2/15/17	APPROVAL COMMENTS	JTB	DBH				
REV.	DATE	REMARKS	DWG	CHK	APPV	SHOP	
MATERIAL:	A270-50W (UN)	SURFACE PREP. & PAINT:	SEE DWG GN	HOLES:	6 1/8 (UN)	SHOP BOLTS:	NONE
DESCRIPTION: GIRDER IGI							
CASCO BAY STEEL STRUCTURES, INC. 1 MILLING AVE. PHONE 802-780-8782 SOUTH PORTLAND, ME 04861 FAX 802-780-8788							
STRUCTURE:	TH-1, FRS RT. 021 / HUNTINGTON RIVER	DRAWN:	JTB	DATE:	01/18		
	RURAL MAJOR COLLECTOR	CHKD:	DBH	DATE:	01/18		
	COUNTY OF CHITTENDEN						
LOCATION:	TOWN OF HUNTINGTON, VERMONT	JOB NO.	030132	DMC NO.	1		
PROJ. NO.	STATE PROJ. BF-021(32)	895-1					
CUSTOMER:	VERMONT AGENCY OF TRANSPORTATION	REV.

Vermont Agency of Transportation
RECEIVED
 CK'D BY: Rob Young
 OK'D BY: Rob Young
 February 16, 2017
 RESUBMIT: Approved As Noted
 BY: Rob Young DATE: 03/05/2017

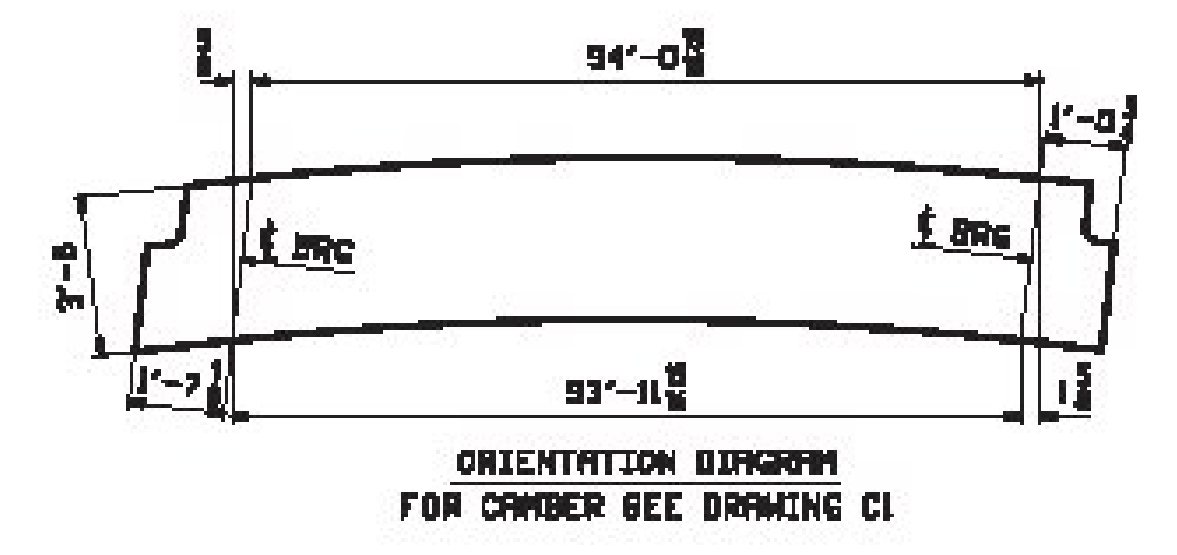
APPROVER CONFIRMED FOR THE GIRDER ENDS, PLEASE CONFIRM WEB COPE SIZE AND THE POSITION OF SLOTTED HOLES ARE ACCEPTABLE (TYP).
